# Access Compliance Report

## Public Rights-of-Way

### (Curb Ramps)

Intersection ID: 12761	Main Street: S_MINT_ST	Cross Street: W_CARSON_BV	Location: N
ADA ID: 2B322F5229EC	Ramp Type: PerpDiag	Initial Pass/Fail: Fail	Overall Compliance: No
			Severity Score: 26.25

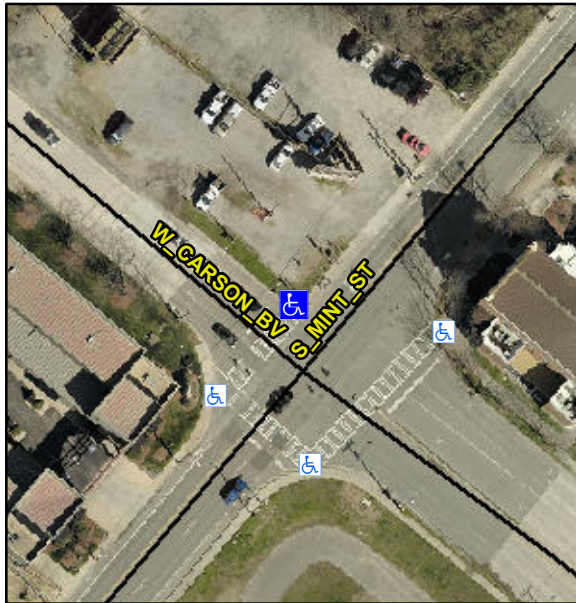
**Not Found, R304.2.2, R304.5.3**

Compliance	Description	Data	Compliance	Description	Data
N/A	Ramp Length (in)	55.0	No	Ramp Slope (%)	12.9
Yes	Ramp Width (in)	48.0	No	Ramp XSlope (%)	2.9
N/A	Flare Type LT	N/A	N/A	Flare Type RT	N/A
N/A	Flare Slope LT (%)	N/A	N/A	Flare Slope RT (%)	N/A
N/A	Flare Traversable LT?	N/A	N/A	Flare Traversable RT?	N/A
N/A	Landing Length (in)	N/A	N/A	DWS Provided?	N/A
N/A	Landing Width (in)	N/A	N/A	DWS Contrast?	N/A
N/A	Landing Slope (%)	N/A	N/A	DWS Length (in)	N/A
N/A	Landing X Slope (%)	N/A	N/A	DWS Full Width?	N/A
N/A	Landing Curb? (Y/N)	N/A	N/A	DWS Offset (in)	N/A
N/A	Shared Landing?	N/A			
N/A	Gutter Ponding?	N/A	N/A	Gutter Slope (%)	N/A
N/A	Gutter Lip Ht (in)	N/A	N/A	Gutter X Slope (%)	N/A
N/A	Painted X Walk1?	Yes	N/A	Painted X Walk2?	No
	X Walk 1 Direction	To SW		X Walk 2 Direction	To SE
N/A	X Walk 1 Width (in)	100.0	N/A	X Walk 2 Width (in)	N/A
	X Walk 1 Slope (%)	3.0		X Walk 2 Slope (%)	0.8
	X Walk 1 X Slope (%)	0.2		X Walk 2 X Slope (%)	2.4

**Remove & Replace Curb Ramp With Two New Directional Ramps or Equivalent.**
